CRITICAL SERVICE BULLETIN

CSB 02-2C

REASON FOR REVISION : Revision issued to increase total time limitation from 250 hour to 500 hours.

SUBJECT: STARTER ADAPTER SHAFT SEAL INSPECTION

FIGURE 1
P/N 642087A XX Starter Adapter

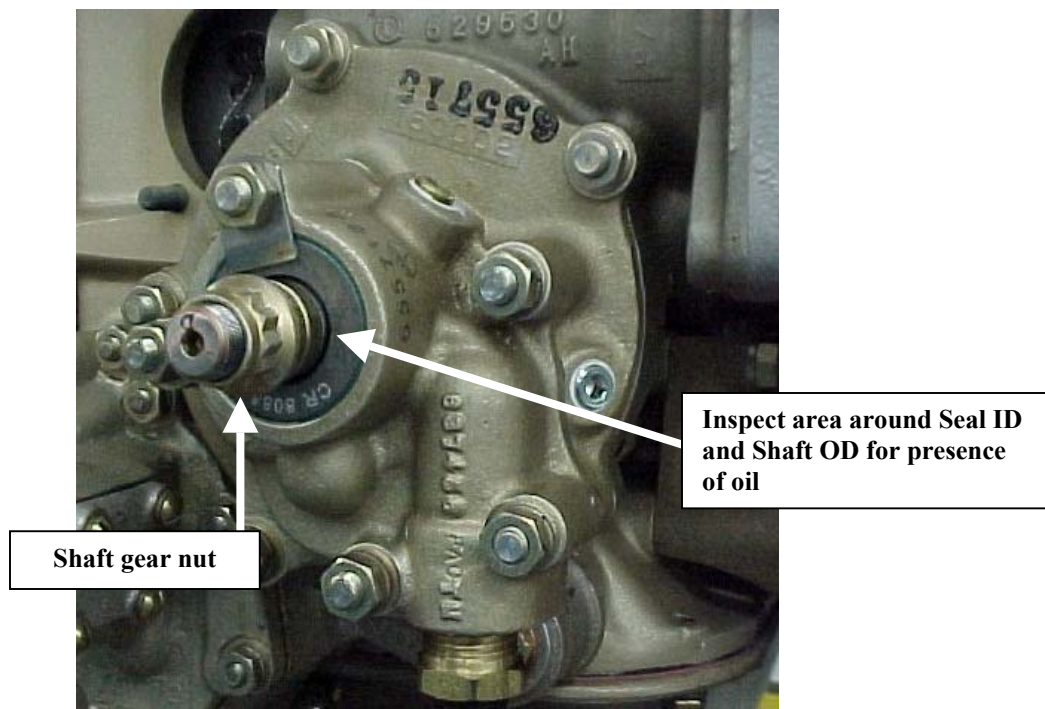
Service Bulletin does not apply. If the starter adapter installed on your engine does have a shaft extending past the rear cover of the starter adapter (Figure 1), inspect the area around the oil seal ID and the starter adapter shaft OD for the presence of oil that may indicate a shaft issue.

If there is oil present, determine if the starter adapter shaft gear has fractured by attempting to rotate, in a clockwise direction, the shaft gear using the correct size 12 point wrench or socket engaged on the shaft gear nut. Reference Figure 1.

If the shaft gear nut does not readily turn or results in the engine and propeller rotating, the shaft gear is not fractured. Determine the source of the oil and take appropriate correction action.

If the shaft gear turns with a minimal amount of force, the shaft gear is fractured and the starter adapter will require replacement prior to further flight.

FIGURE 2
655711 Shaft Gear

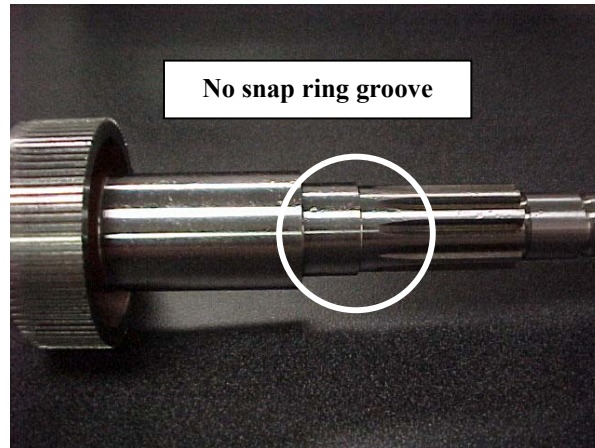
The starter adapter shaft gear P/N 655711 replaces shaft gear P/N 649866. The P/N 655711 shaft gear does not have the snap ring groove machined just aft of the first shoulder as noted in Figure 2.

FIGURE 3
P/N 642087A "XX" Starter Adapter

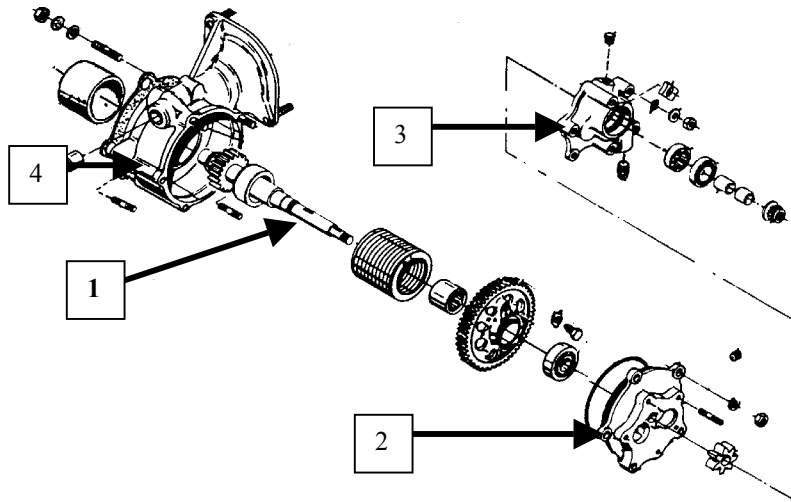
TCM has implemented a production change to the starter adapter cover, scavenge pump housing and starter shaft gear. Refer to FIGURES 1, 2 and 3. The starter adapter cover P/N 640747 has been replaced by P/N 655714 cover. The P/N 655714 contains two alignment dowels, one at the 5 o'clock stud and another at the 7 o'clock stud. The scavenge pump housing P/N 652019 has

been replaced by the P/N 655715A1 housing. The P/N 655715A1 housing has the mating 5 o'clock and 7 o'clock stud holes machined to accommodate the alignment dowels.

All starter adapters overhauled or repaired in the field must be assembled using the parts noted in Figure 3, or subsequent part numbers. Shaft gear P/N’s 640745, 640803, 649882 and 649866 must be removed from service and replaced with P/N 655711 or subsequent part number shaft gear. P/N 655714 (Cover- item 2 Figure 3) and P/N 655715 (Housing, Scavenge Pump- item 3 Figure3) are manufactured with alignment dowels and must be used together. Do not use either P/N 655714 or P/N 655715 with previous superseded mating parts.
